CALL NO. 303
CONTRACT ID NO. 162316
ADDENDUM # 1

Subject: Larue County, FD05 062 0061 008-011
Letting November 18, 2016

- (1) Revised - Note - Page 9 of 82
- (2) Revised - Typical Section - Pages 27-28 of 82
- (3) Revised - Bid Items - Page 82 of 82

**TYPICAL HALF SECTION
LARUE COUNTY
FD05 062 0061 008-011
MICROSURFACE ALTERNATE
MP'S 8.031 TO 10.246**

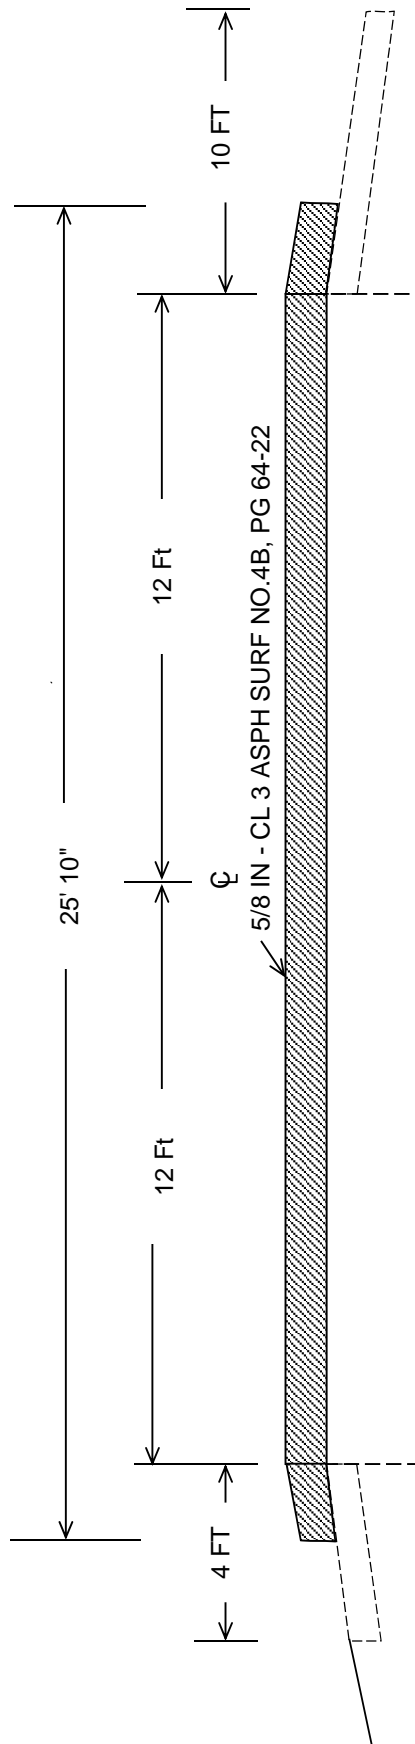
- Note:
- 1). OVERLAY INSIDE TO INSIDE EXISTING SAWED RUMBLE STRIPS
 - 2). OVERLAY ALL LEFT TURN LANES AND MEDIAN CROSSOVERS
 - 3). PAVEMENT MARKERS SHALL BE REMOVED AND THE ALTERNATE SURFACE MATERIAL PLACED TO FILL EXISTING HOLE
